**Town of Kittery  
Planning Board Meeting  
August 11, 2016**

**91 Route 236 – Major Modification to an Approved Plan – Completeness Review**

**Re: Kittery Storage Solutions  
Site Plan Amendment Application  
Tax Map 28, Lot 14-1**

**SCHEMATIC BUILDING SECTION**

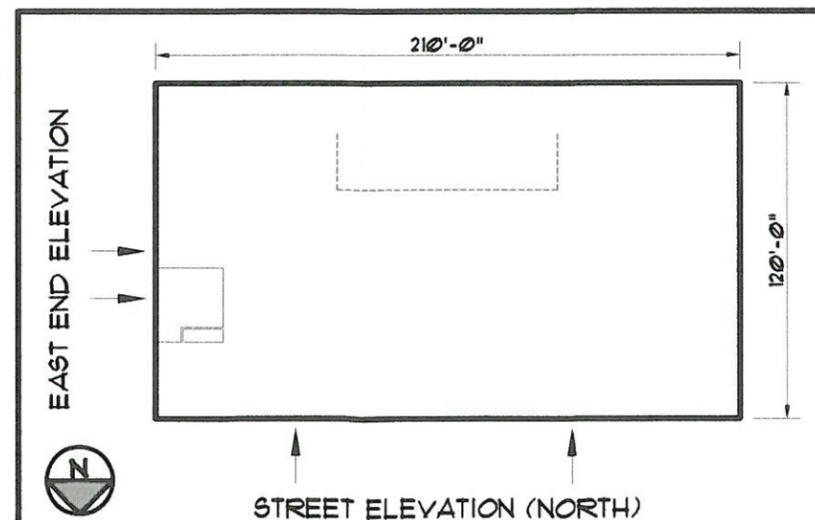
3. Building Height: The proposed building height as depicted on the architectural plans prepared by JD LaGrasse & Associates is 39 feet and 4 inches where the maximum permitted in the C-2 zone is 40 feet. The pertinent definition for *Height of a Building* in 16.2.2 requires that the height be measure from the average grade along the original ground. Staff has estimated this to be around 45 feet (lowest levitation contours shown are 43 and the highest are 47 as depicted on sheet 2, grading & utility). The proposed elevations for the base of the building appear to be 47.9 feet.

The plan should be revised to conform the requirements of the definition or request a special exception as allowed under 16.3.2.11.C.2.k. This seems reasonable since the proposed use *Warehousing and storage* is a special exception use (16.3.2.11.C.2.f).
